## STAFF REPORT

### Conditional Use (CU-04-16) and Replat (RL-01-16) for Church and Parking Lot Expansion Evangel Assembly

DATE OF REPORT: September 13, 2016

**EVANGEL ASSEMBLY**  
**SITE IMPROVEMENT PLAN**  
FISHER CONSTRUCTION SERVICES, INC.  
2815 SE PINE STREET, ALBANY, OREGON

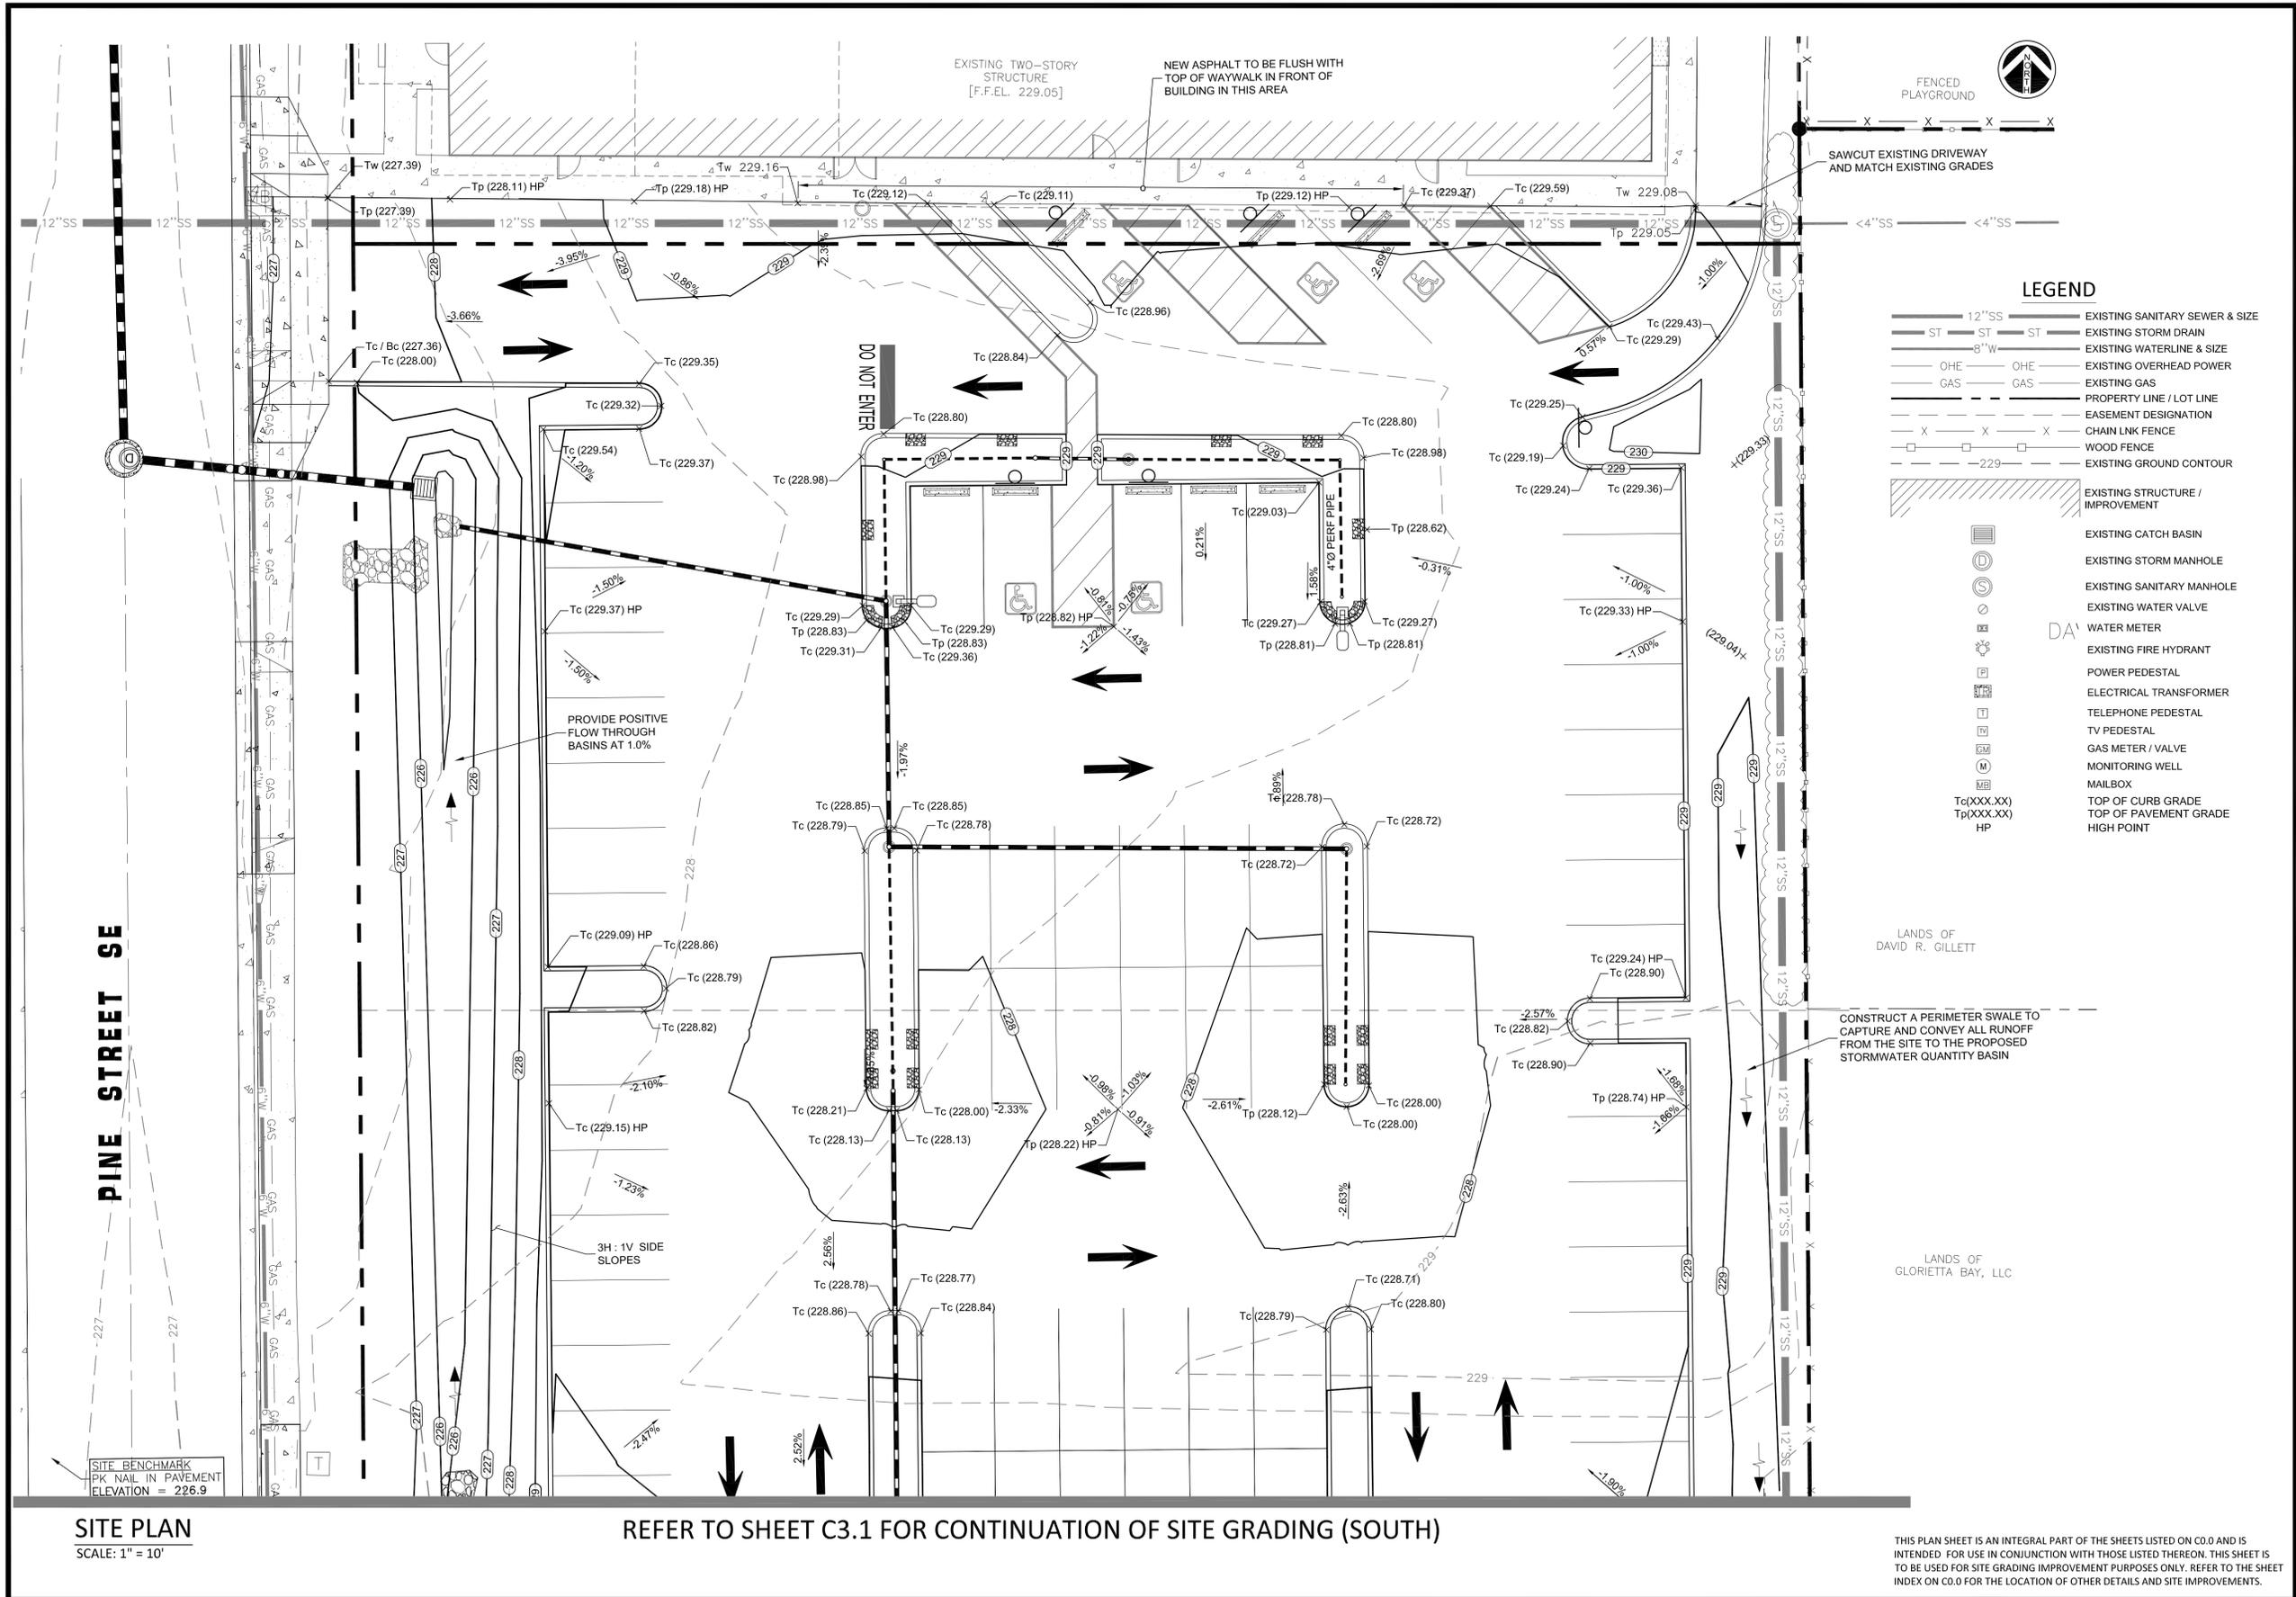
in lot coverage and height; however, setbacks are nonconforming and may remain so. According to ADC 3.250(1), parking and loading spaces may not be located in a required front yard setback. Plans submitted with the application indicate no existing or expanded parking areas will be located within the front setback (see Attachment D.3). The proposed 1,230-square foot church addition is shown to have a setback of 23.75 feet from the property line abutting 28<sup>th</sup> Avenue SE; therefore, the required 25-foot setback is not met. The applicant must either revise building plans to comply with the setback standard or receive an approved Adjustment to allow a reduced setback. This will be made a condition of approval (Condition 2.7, below).

- 2.8 Parking Lot Design and Construction. Parking lots must be paved, landscaped, and provided with approved drainage. ADC 9.120(3) states that all areas of a parking lot shall have a durable, dust-free surface of asphalt, cement concrete, or other materials approved by the Director of Public Works. ADC 9.120(8) states that lots containing more than two parking spaces must have all the required spaces permanently and clearly striped. Stripes must be at least four inches wide. A site plan showing existing conditions illustrates the location of the existing parking area. The existing parking area will be reconstructed when the additional 57 spaces are developed. The converted office space will utilize the existing driveway off Geary Street to accommodate three required spaces. All proposed on-site parking meets dimensional standards in ADC 9.130.

- 2.7 Prior to issuance of a building permit, the applicant shall revise building plans for the new addition to the church in order to meet the required 25-foot front yard setback or receive an approved Adjustment permit to reduce the required front setback to 23.75 feet.

**EVANGEL ASSEMBLY**  
**LANDSCAPE PLAN**  
 FISHER CONSTRUCTION SERVICES, INC.  
 2815 SE PINE STREET, ALBANY, OREGON

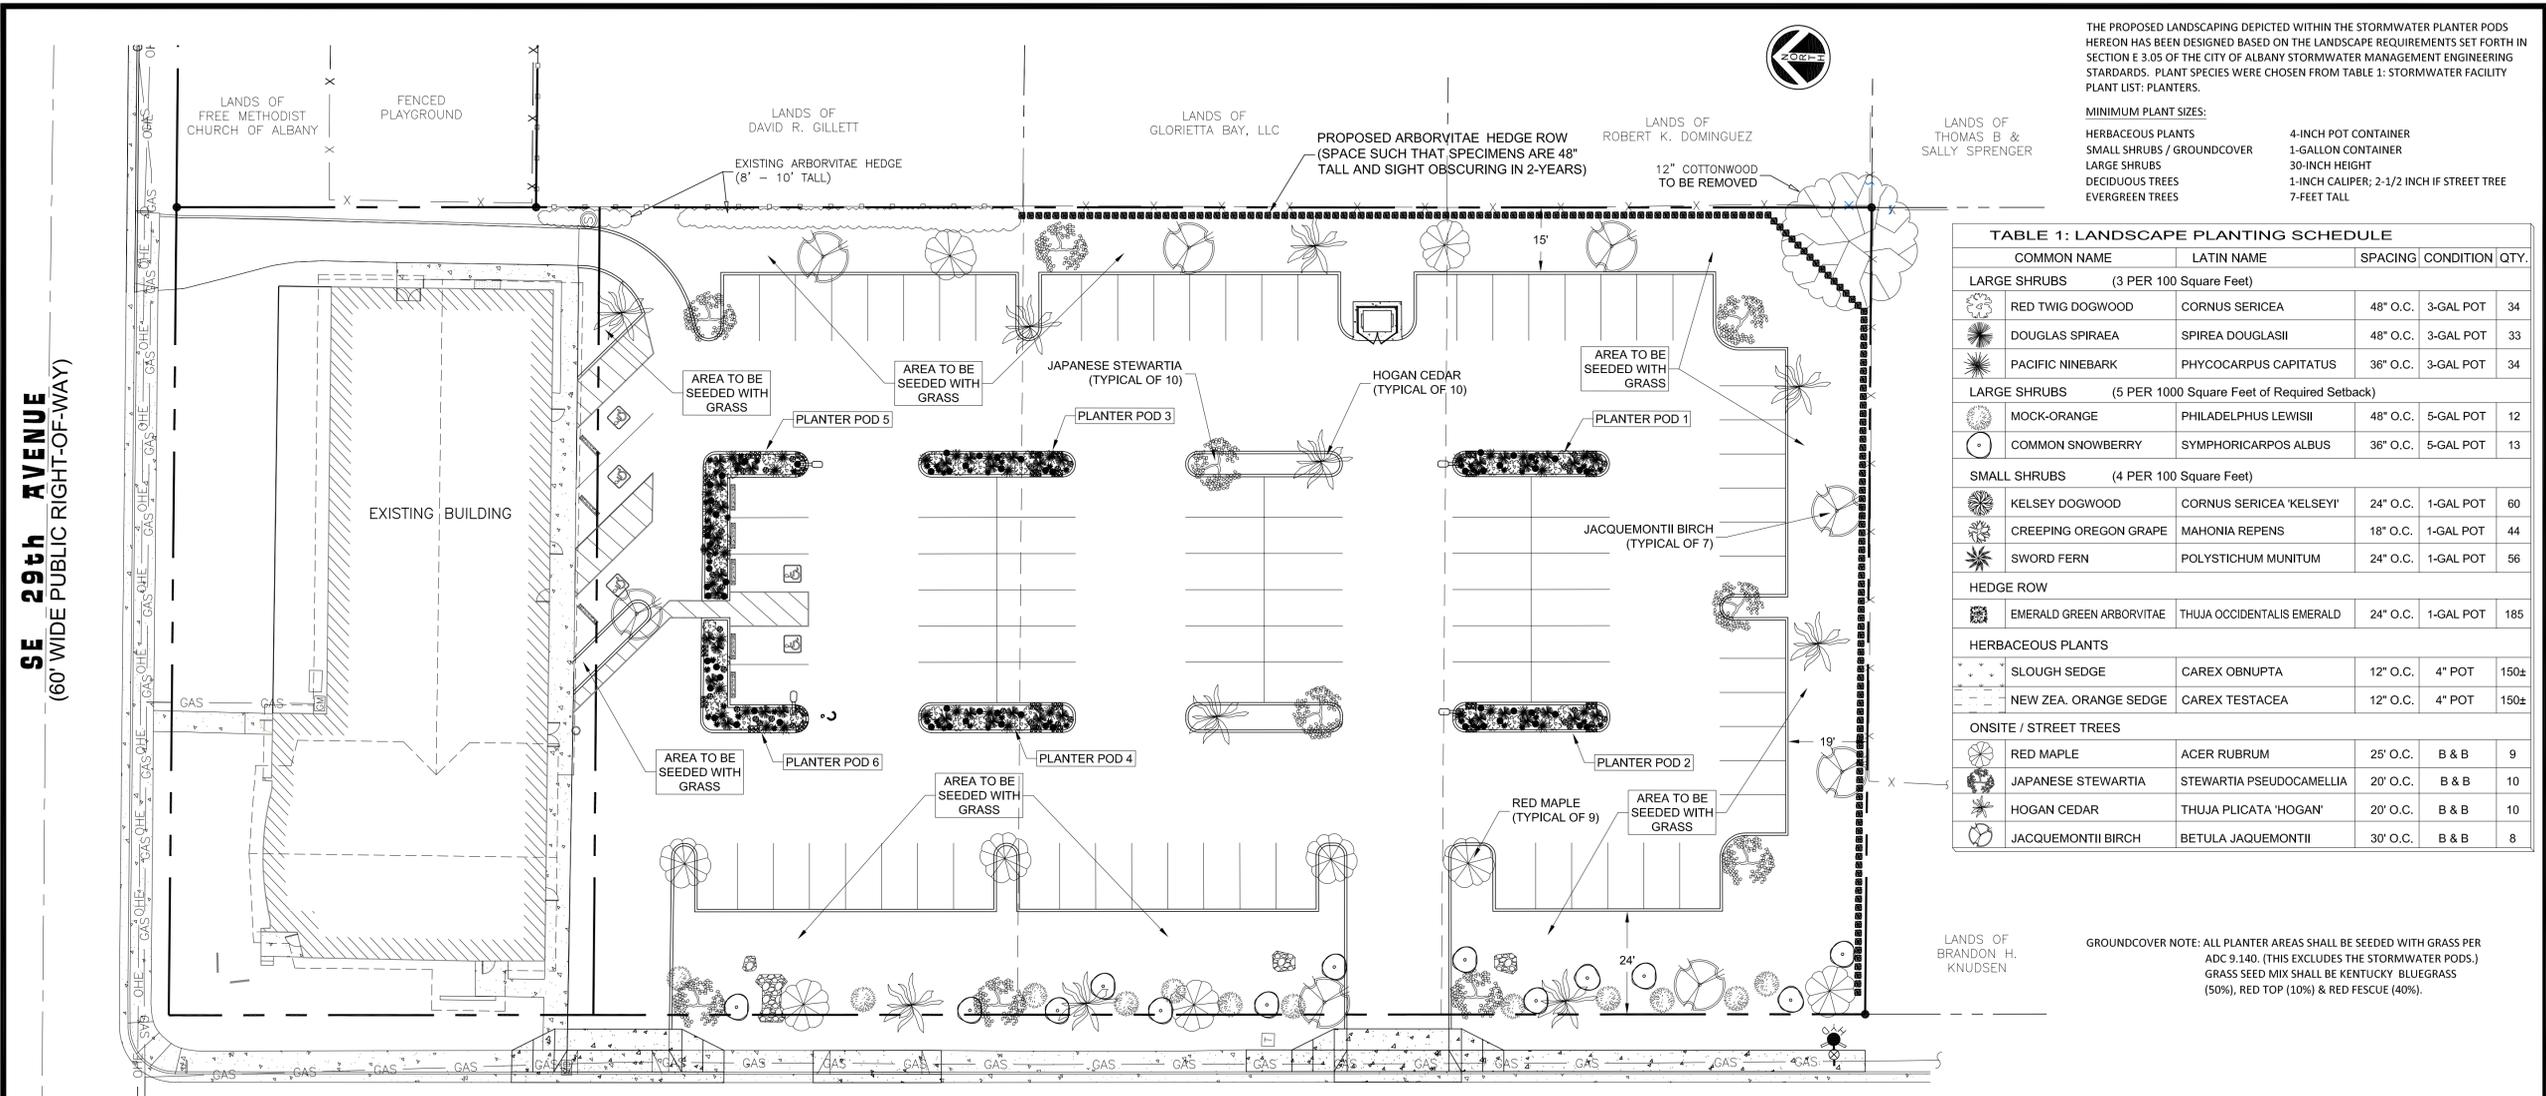
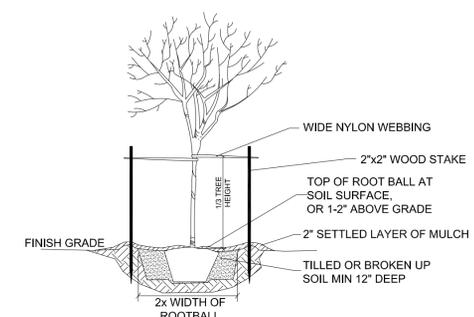
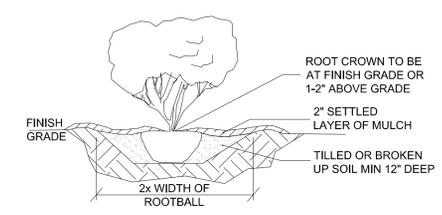
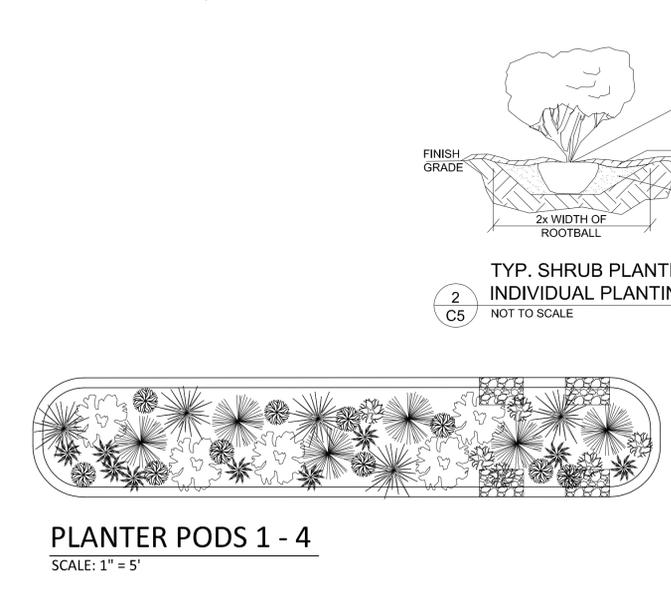
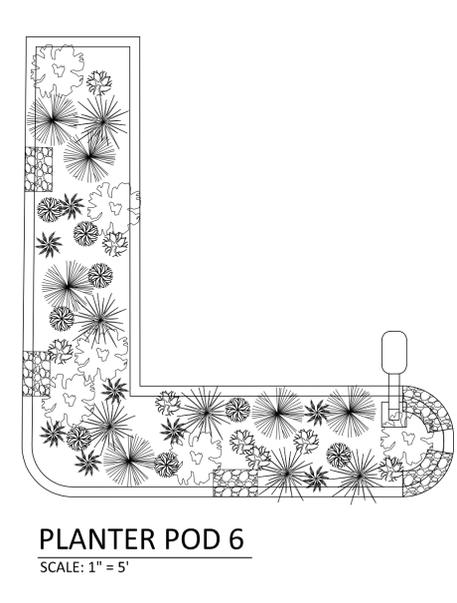
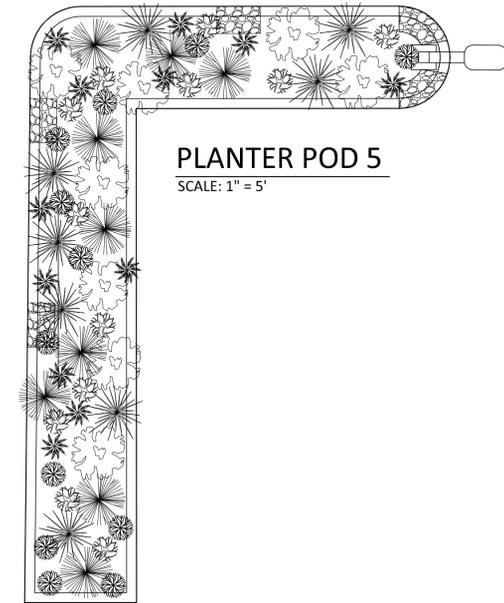
Accessways and permitted intrusions along the building's Pine Street frontage consist only of a pedestrian path, about five feet wide leading to the public sidewalk. The remaining frontage is 95 lineal feet, or 1,425 square feet. Specific amounts of landscaping are two trees at least six feet tall, eight one-gallon shrubs or accent plants, and attractive ground cover. Continuing south on Pine Street, the existing parking lot and the proposed parking expansion area have a combined 300 lineal feet of frontage. Accessways and intrusions existing and proposed include two 24-foot wide driveways, for a total of 48 feet. Therefore, 252 lineal feet of frontage (3,780 square feet in area) will require the following landscaping five trees at least six feet tall, twenty one-gallon shrubs or accent plants, and attractive ground cover. Existing trees and shrubs that meet minimum size requirements can be applied toward the required amounts. Revised landscape plans submitted August 5, 2016, show proposed landscaping in the parking lot frontage along Pine Street consisting of eleven trees (red maple, Japanese stewartia, Hogan cedar, and Jacquemontii birch) with a minimum 2.5-inch caliper (or seven feet in height for evergreen species). Plans also show 25 five-gallon accent plants (Attachment D.7). Both plantings exceed the minimum number required by the Code.

A buffer is proposed that will consist of one row of deciduous trees planted every 30 feet together with grass. These are shown on the applicant's landscape plan (Attachment D.7). The applicant is asking to have an alternative considered that would count trees planted in the parking lot planter bays as buffer trees to avoid crown-crowding. The landscape plan only shows two planter islands containing two trees each. Staff does not support this alternative. Neither the number of trees nor their location meets the intent of a buffer. The given distance for the row of buffer trees is about 300 feet, requiring a row of at least ten trees. In addition, it is the combination of buffer and screening that will help mitigate headlights and other parking lot impacts for the abutting residential property owners to the east and south.

- 2.4 Prior to issuance of a building permit, a revised landscape plan showing compliance with front setback, parking lot, and buffer and screening standards will be required for review and approval by the Planning Division. Nine additional one-gallon shrubs or accent plants will be required within the front setback area abutting 28<sup>th</sup> Avenue; two trees at least six feet tall, eight one-gallon shrubs or accent plants, and attractive ground cover will be required along the church's Pine Street frontage; a minimum of five trees at least six feet tall, twenty one-gallon shrubs or accent plants, and attractive ground cover will be required along the parking lot frontage abutting Pine Street.
